TECHNICAL SERVICE BULLETIN

Luggage Compartment Scuff Plate To Luggage Compartment Side Trim Panel Gap

24-2422

Ford
2024 Mustang

Figure 1

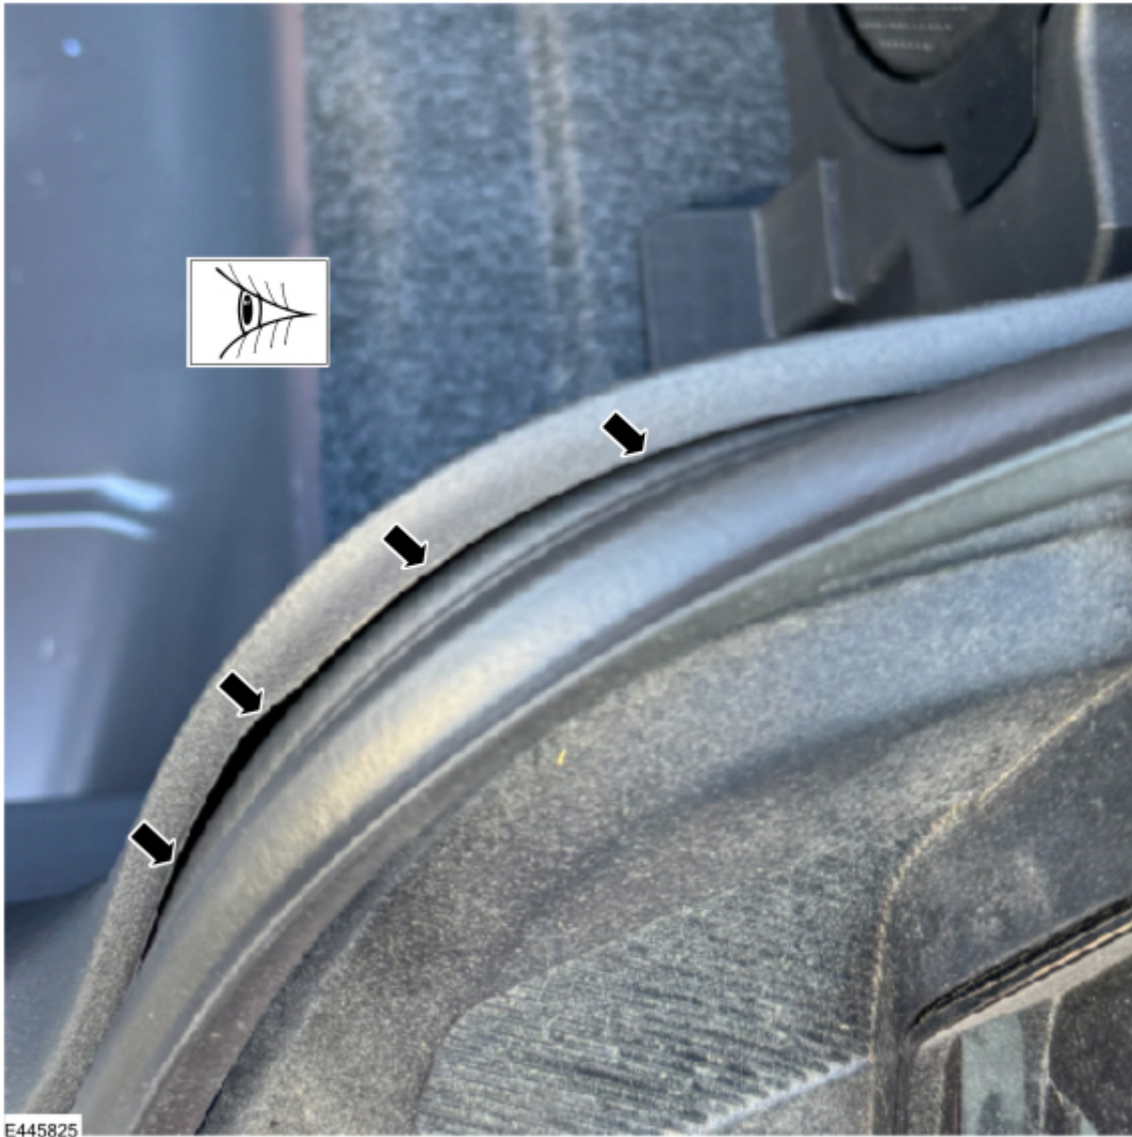
Issue: Some 2024 Mustang vehicles may exhibit the luggage compartment scuff plate with a gap near the right or left luggage compartment side trim panel. This may be due to the luggage compartment scuff plate installation. To correct the condition, follow the Service Procedure to replace the luggage compartment scuff plate.

1. Does the luggage compartment scuff plate to luggage compartment side trim exhibit a gap similar to Figures 1-2? (Right side shown in figure 2, Left side similar)

(1). Yes - proceed to Step 2.

(2). No - this article does not apply.

Figure 3

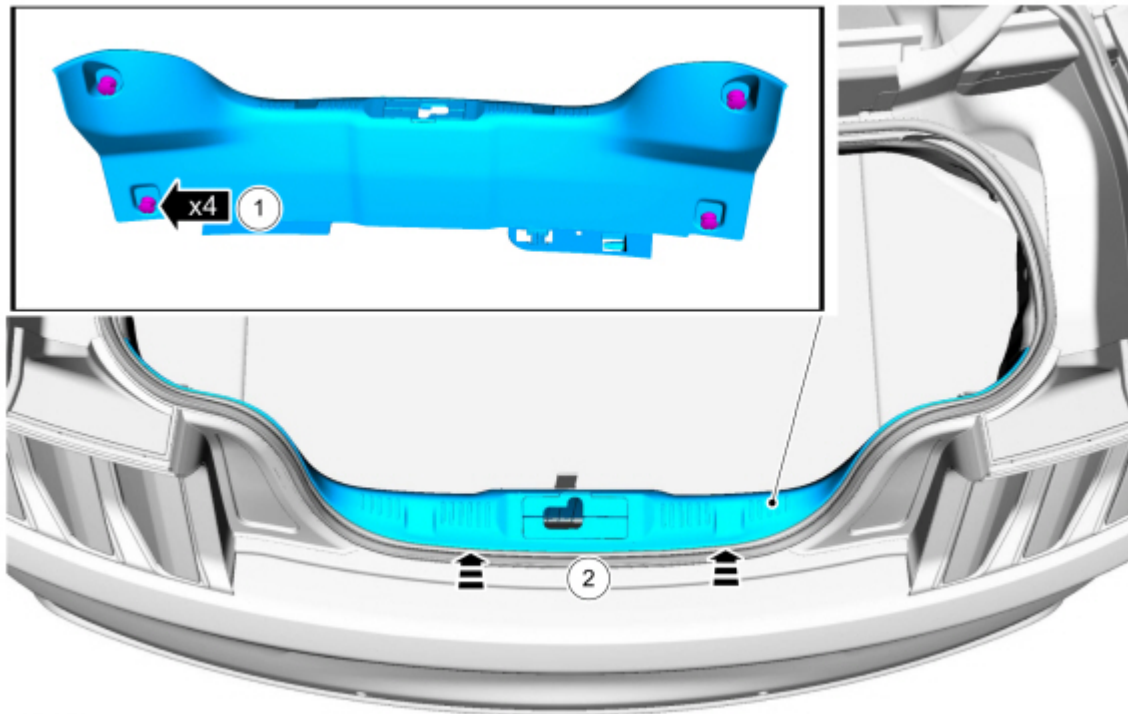
2. Remove the luggage compartment scuff plate by unscrewing the thumb nut type retainers. (Figure 3)

3. Install the new luggage compartment scuff plate.
